THE FARM LOT 1
BROKEN ARROW, OKLAHOMA

PRELIMINARY PLAT

SHEET NUMBER:
C1.1

Vicinity Map

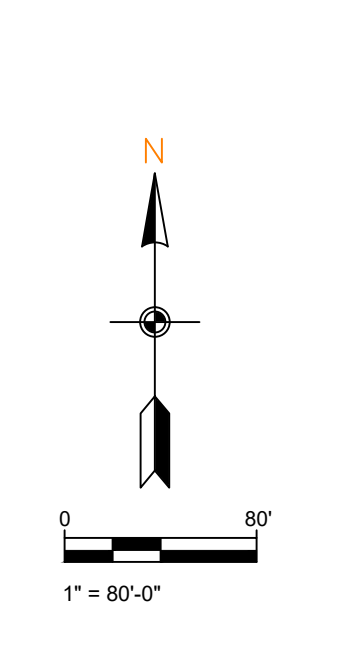
E06
The maximum scale on a location map is 1:2000 showing the USGS section, identifying the section, township, and range. Show the boundaries of the platted areas within the section with the names. Show the names of the arterial streets using the BA names, county names may be included in (parenthesis) This applies to the P03 comment

PRELIMINARY PLAT

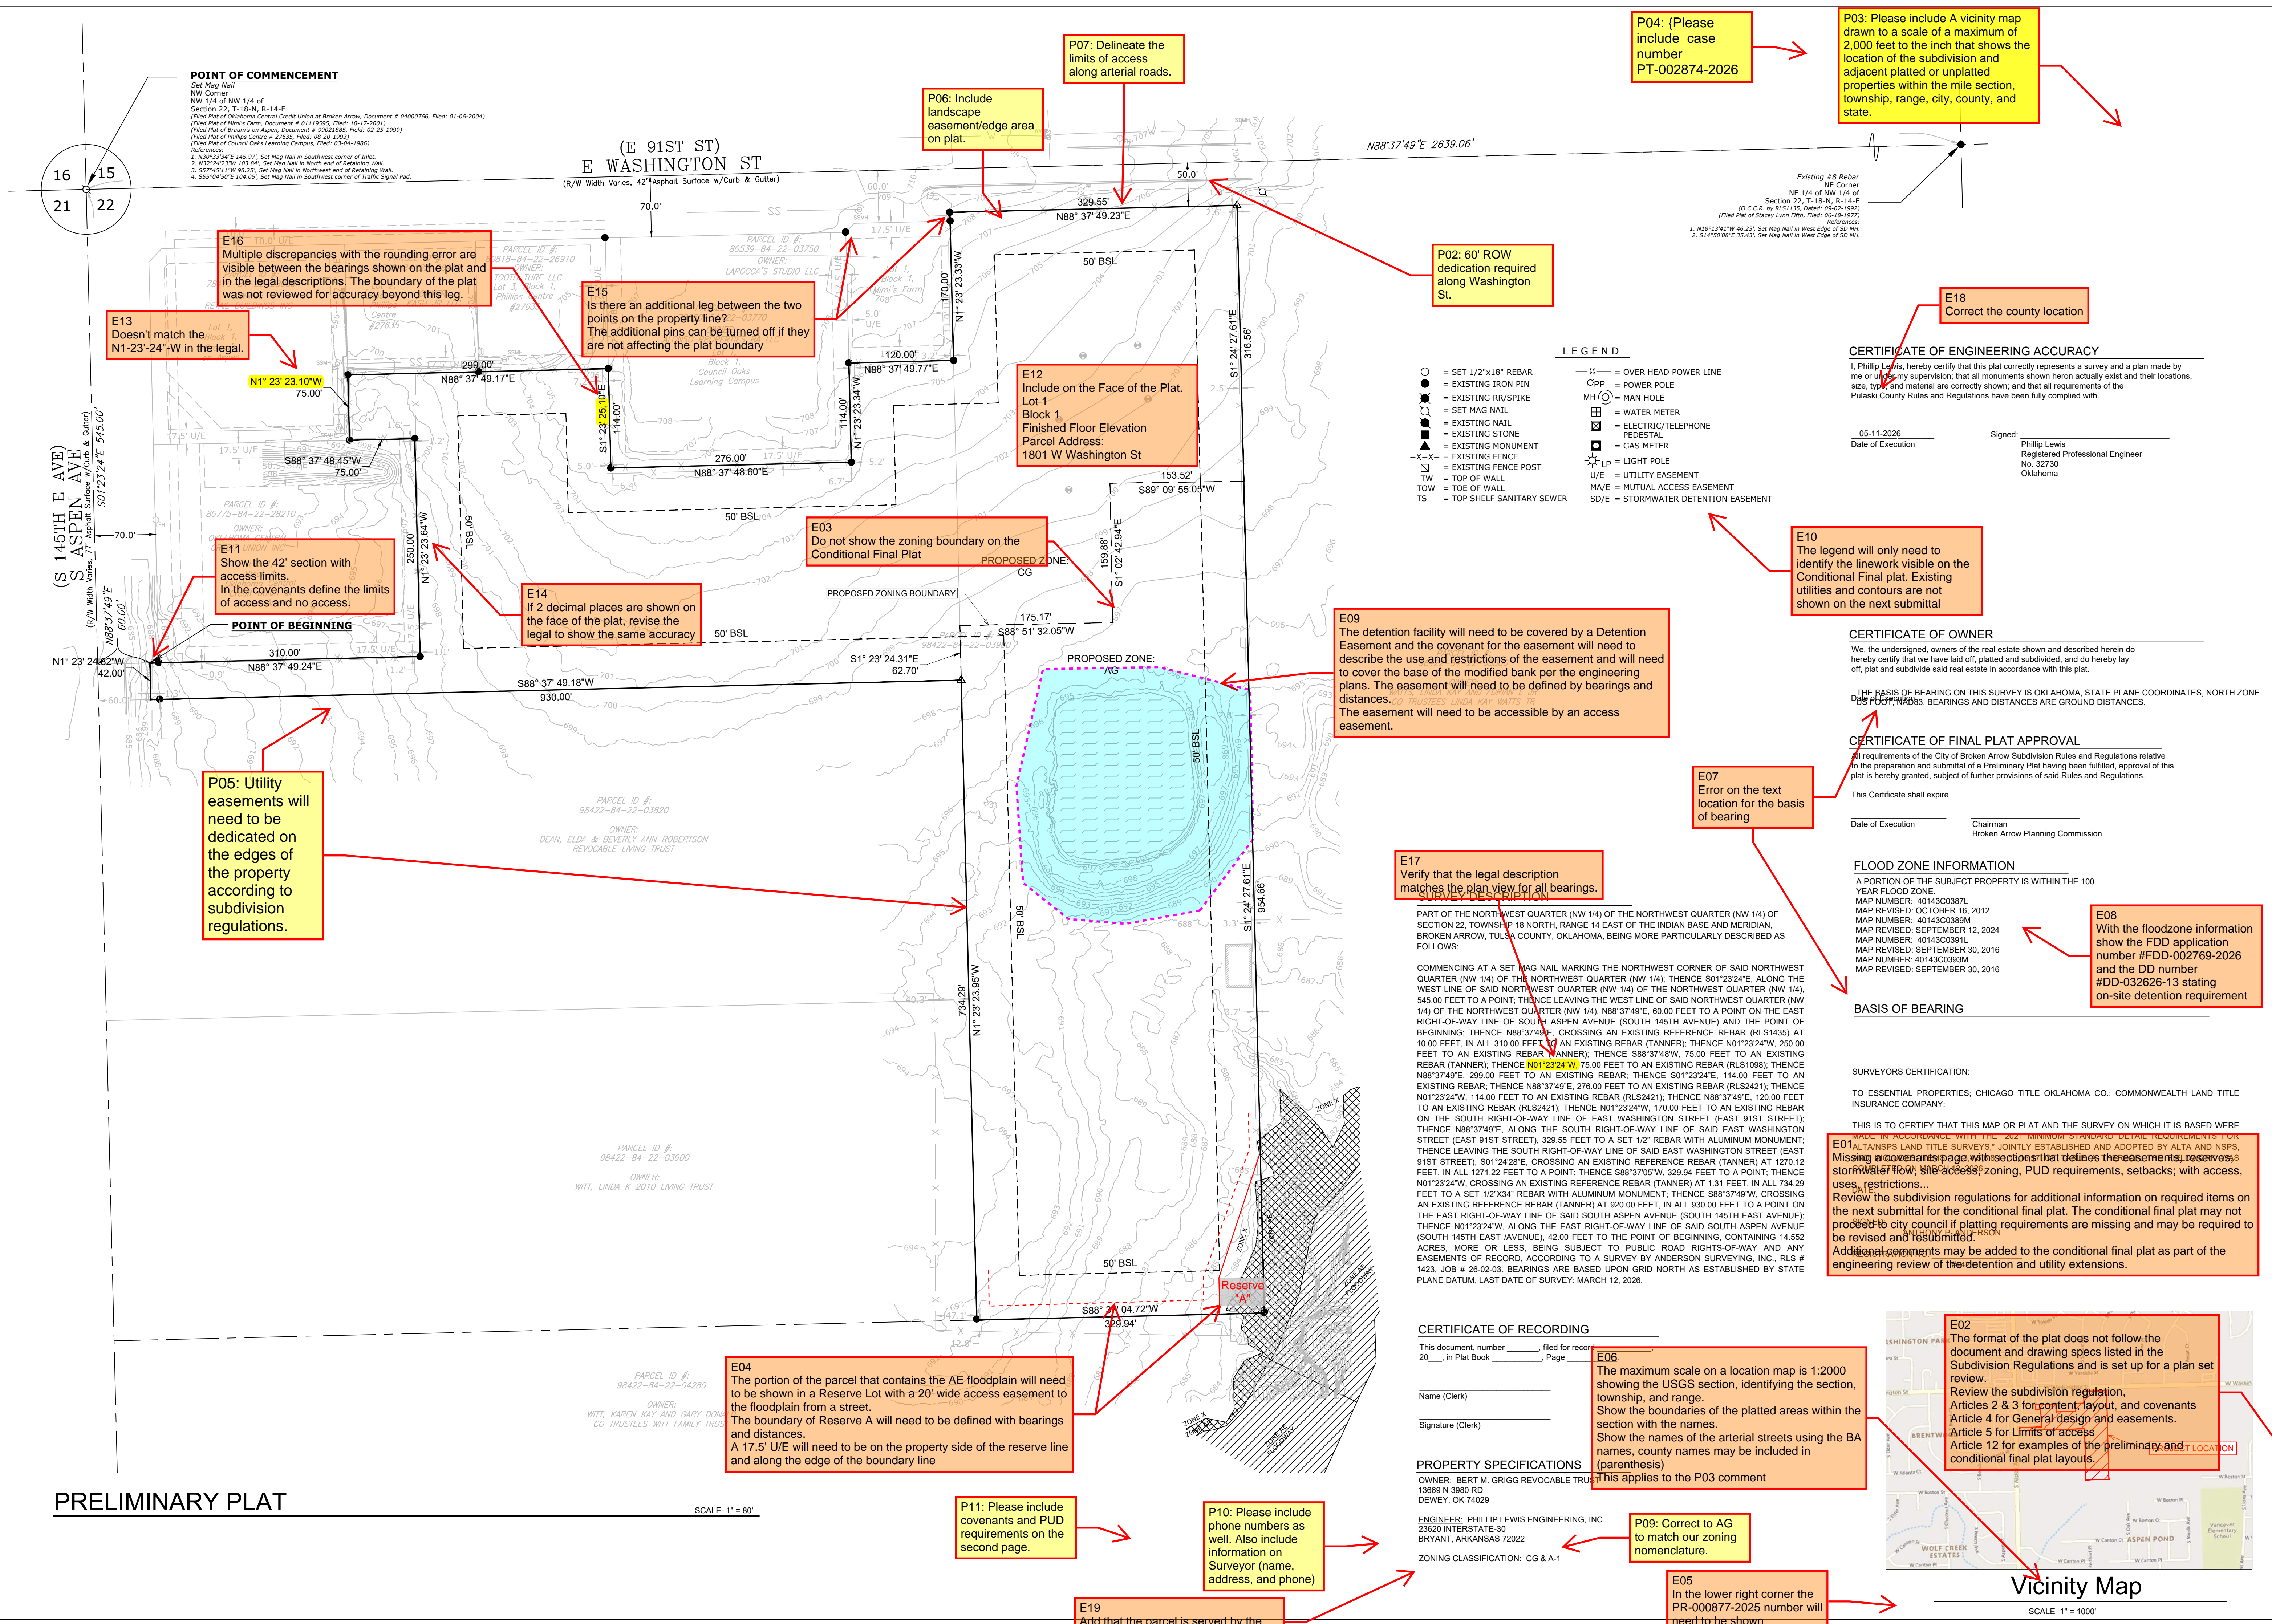
REVISION:
P08: Include PUD-002514-2025 number in title of plat.

P01: A more specific name will be needed as there are many areas in Tulsa County platted as The Farm at...

E13
Doesn't match the N1-23-24-W in the legal.

E16
Multiple discrepancies with the rounding error are visible between the bearings shown on the plat and in the legal descriptions. The boundary of the plat was not reviewed for accuracy beyond this leg.

E15
Is there an additional leg between the two points on the property line? The additional pins can be turned off if they are not affecting the plat boundary

P06: Include landscape easement/edge area on plat.

P07: Delineate the limits of access along arterial roads.

P02: 60' ROW dedication required along Washington St.

P04: (Please include case number PR-002874-2026

P03: Please include A vicinity map drawn to a scale of a maximum of 2,000 feet to the inch that shows the location of the subdivision and adjacent platted or unplatted properties within the mile section, township, range, city, county, and state.

E18
Correct the county location

E12
Include on the Face of the Plat. Lot 1, Finished Floor Elevation: 1801 W Washington St

E03
Do not show the zoning boundary on the Conditional Final Plat

E11
Show the 42' section with access limits. In the covenants define the limits of access and no access.

E14
If 2 decimal places are shown on the face of the plat, revise the legal to show the same accuracy

E10
The legend will only need to identify the linework visible on the Conditional Final plat. Existing utilities and contours are not shown on the next submittal

E09
The detention facility will need to be covered by a Detention Easement and the covenant for the easement will need to describe the use and restrictions of the easement and will need to cover the base of the modified bank per the engineering plans. The easement will need to be defined by bearings and distances. The easement will need to be accessible by an access easement.

E07
Error on the text location for the basis of bearing

P05: Utility easements will need to be dedicated on the edges of the property according to subdivision regulations.

E17
Verify that the legal description matches the plan view for all bearings.

E08
With the floodzone information show the FDD application number #DD-002769-2026 and the DD number #DD-032626-13 stating on-site detention requirement

E04
The portion of the parcel that contains the AE floodplain will need to be shown in a Reserve Lot with a 20' wide access easement to the floodplain from a street. The boundary of Reserve A will need to be defined with bearings and distances. A 17.5' U/E will need to be on the property side of the reserve line and along the edge of the boundary line

P11: Please include covenants and PUD requirements on the second page.

P10: Please include phone numbers as well. Also include information on Surveyor (name, address, and phone)

P09: Correct to AG to match our zoning nomenclature.

E05
In the lower right corner the PR-000877-2025 number will need to be shown
